Dominion Supplemental Projects

Transmission Expansion Advisory
Committee
August 4, 2026

Dominion Transmission Zone: Supplemental Atlas 230kV Delivery - DEV

Need Number: DOM-2023-0011

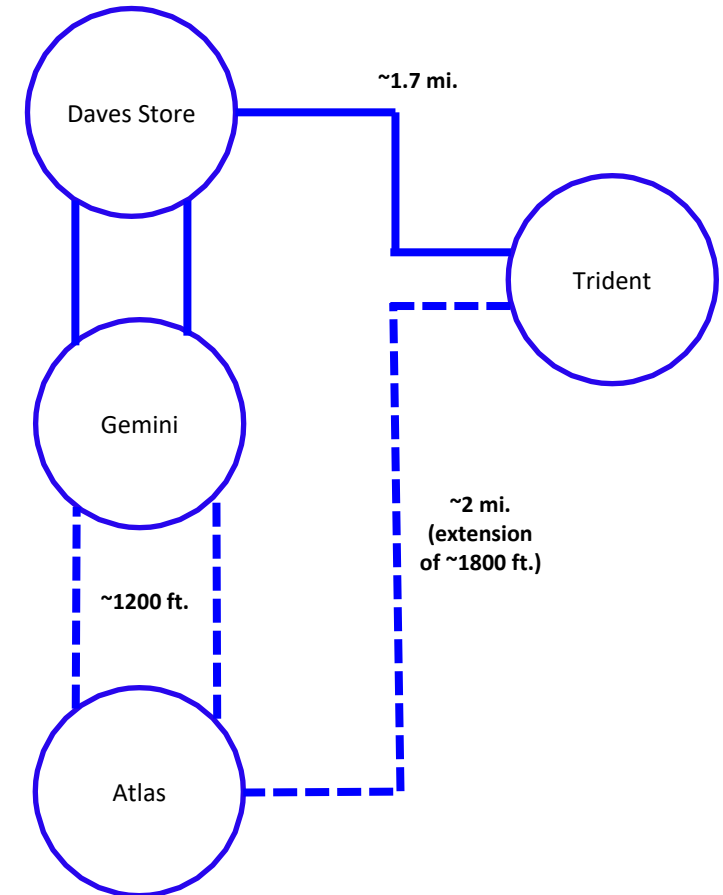
- Interconnect the new substation by extending approx. 1200' of ~~(4)~~ (2) new 230 kV lines from Gemini to the proposed Atlas Substation. Re-terminate (1) of the 230 kV segments from Daves Store to Trident (DOM-2023-0009-DNH) into Atlas, extending the segment by approx. 1800'. The 230 kV lines will terminate into a 230 kV ~~four-breaker arrangement expandable to an ultimate of six GIS~~ arrangement of (9) 230 kV breakers in a breaker-and-a-half scheme.
- Install (2) 230 kV breakers at Gemini Substation to accommodate the termination of the (2) lines from Atlas.

Estimated Project Cost: ~~\$10.0 M~~ \$52.9 M

Projected In-service Date: 04/01/2028 ~~06/01/2028~~
